10 August 2010  
Ref 08138

**Proposed Mixed Use Development  
Albert Street and Thomas Street, Chatswood**

I respond to your request to consider and provide advice in relation to the 'traffic issues' raised by the Department of Planning as follows:

**SP 7**

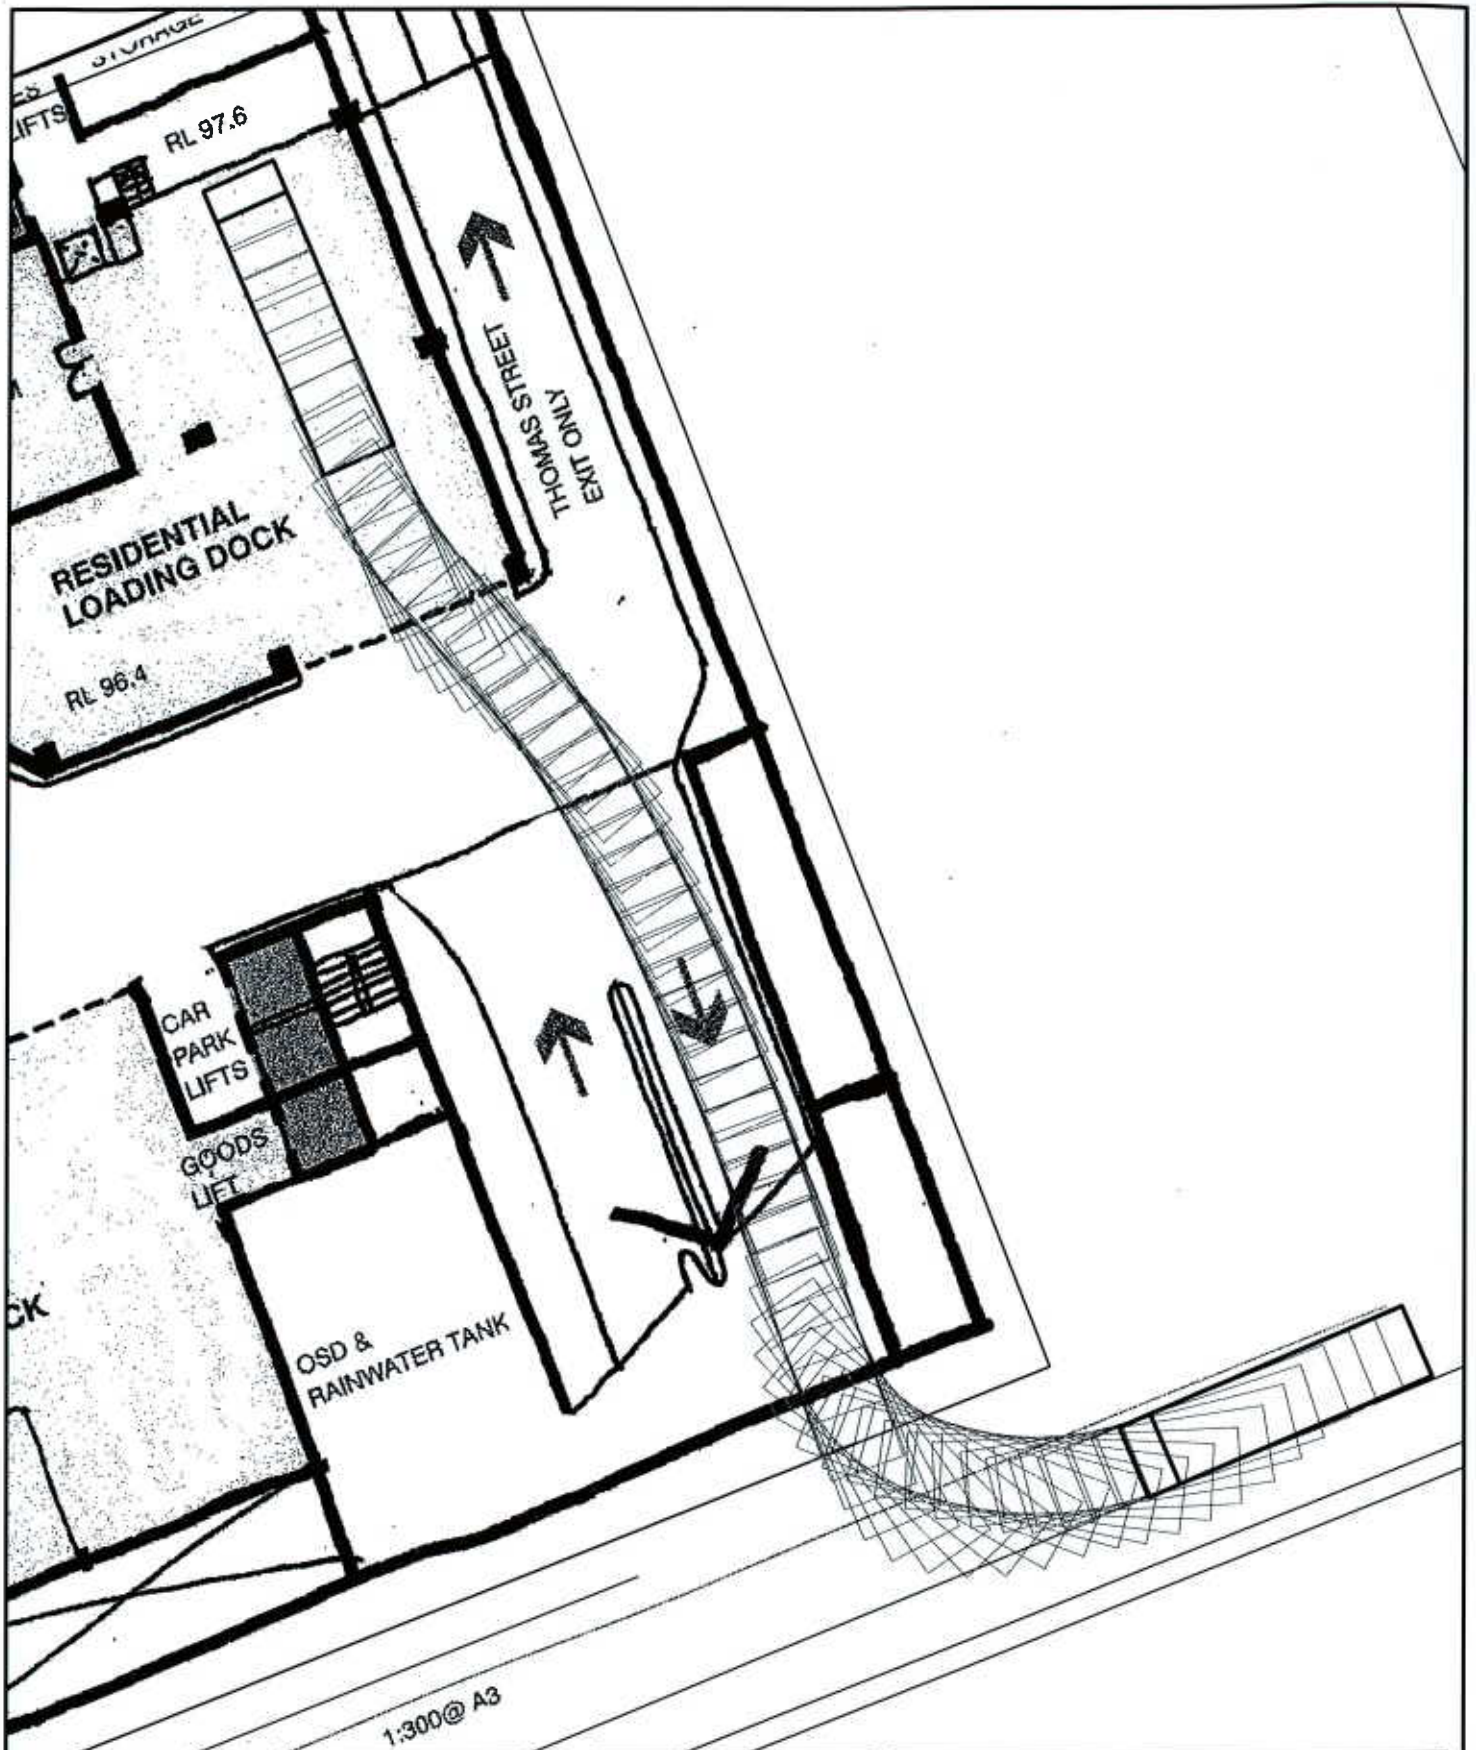
In relation to the ability for trucks to turn within the alternative loading dock arrangements (as shown on the PTW sketch) the attached turning paths SP1-8 clearly demonstrate the ability for MRV and refuse trucks to ingress, turnaround and egress.
